Title - Sujet Aeration Tower Modification	
Solicitation No. - N° de l'invitation F1700-120200/A	Amendment No. - N° modif. 003
Client Reference No. - N° de référence du client F1700-120200	Date 2012-07-26
GETS Reference No. - N° de référence de SEAG PW-\$PWY-004-6729	
File No. - N° de dossier PWY-2-35074 (004)	CCC No./N° CCC - FMS No./N° VME
Solicitation Closes - L'invitation prend fin at - à 02:00 PM on - le 2012-08-01	Time Zone Fuseau horaire Pacific Daylight Saving Time PDT
F.O.B. - F.A.B. Plant-Usine: <input type="checkbox"/> Destination: <input checked="" type="checkbox"/> Other-Autre: <input type="checkbox"/>	
Address Enquiries to: - Adresser toutes questions à: Mestry, Ruth (PWY)	Buyer Id - Id de l'acheteur pwy004
Telephone No. - N° de téléphone (604) 775-9385 ()	FAX No. - N° de FAX (604) 775-6633
Destination - of Goods, Services, and Construction: Destination - des biens, services et construction: DFO - Quinsam River Hatchery, Campbell River, B.C.

Attached is Addendum No. 2

Solicitation: F1700-120200
Aeration Tower Modification – Quinsam River Hatchery

Addendum No. 2

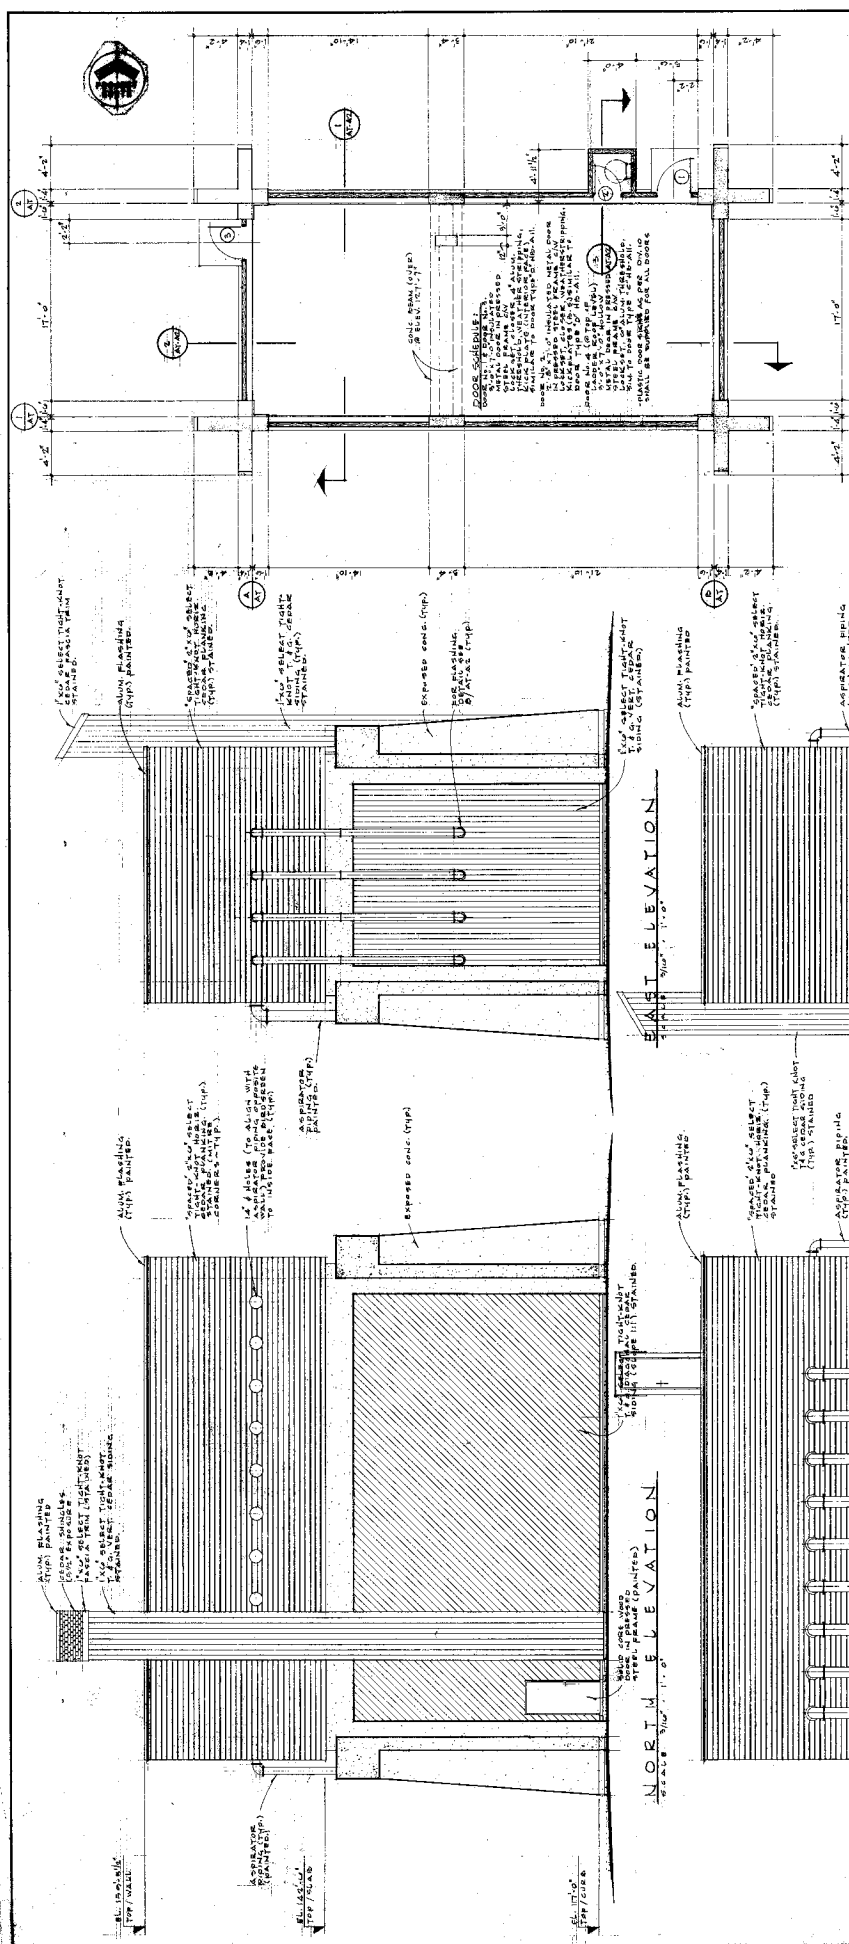
5. How long are we able to shut down the Aeration tower for? We will need to shut it down to tie the 2 90's onto the header as the existing they used a wafer style valve rather than lugged or flanged valve so we are unable to just close the valve and do the tie in?

The main header for the aeration tower cannot be taken out of service during construction. The existing spool piece will need to be cut to length in place and a slip on flange welded to the spool piece. The existing drain and pressure gauge on the spool piece will need to be lowered to accommodate the shorter spool. Any interior and exterior lining or paint on the spool will have to be repaired to existing condition prior to startup.
